! PRODUCT NOTICE

**5380 CompactLogix and Compact GuardLogix
Firmware Versions 29.011 and 32.011 Major Non-Recoverable Fault**

Reference: 2019-07-001

Date: July 2019

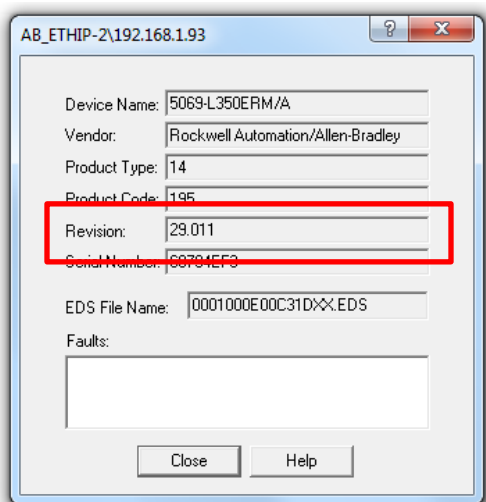
The example to the left shows the properties dialog for a 5069-L350ERM as viewed in Studio 5000 Logix Designer. The firmware version is shown in the Revision field. In this example, the firmware version is 29.011. The firmware in this module would be subject to this notification and should be upgraded as described in the Correction section of this document.

Correction requires installation of a non-affected version of controller firmware. Only firmware versions 29.011 and 32.011 are affected with this anomaly.

- Customers using version 29.011 firmware are advised to upgrade to a later non-affected version of firmware, v30 or later. Version 29.011 customers may also downgrade to a version 28 release if their controller hardware supports prior versions.
- Customers using version 32.011 are advised to upgrade to version 32.012 or later. Version 32.012 is scheduled for release by end of July 2019. Version 32.011 customers may also downgrade to a prior version pending the release of 32.012.
